## UPGRADING OF STANDARD BAMBINO SEAT

UPGRADED BAMBINO SEAT WITH LONG BAR

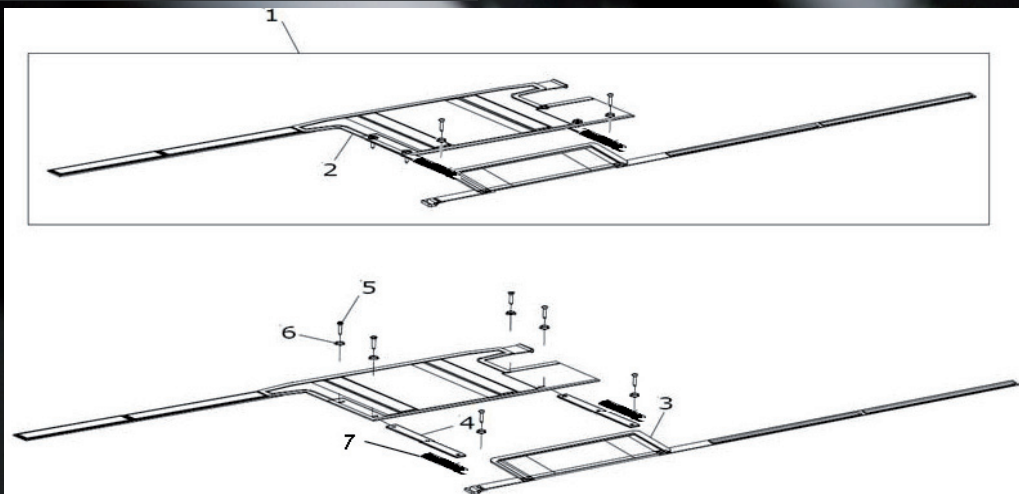
All standard Bambino seat will be upgraded with a new long bar where the seat extender is attached, the same design as the abduction seat. This implicate an easier and more accurate adjustment of the seat depth without interference of the brake.

When you mount the new seat on an old standard chassis, without the pre-drilled holes for the new long bar, you need to use an awl to make screw holes in the chassis. (NOTE! Do not use a drill since it will damage the chassis)  
No change of art.no. and price.

ON OLDER CHASSIS THAT LACKS THE EXTRA HOLE FOR THE NEW BAR, YOU NEED TO USE AN AWL TO MAKE THE HOLE. WATCH VIDEO
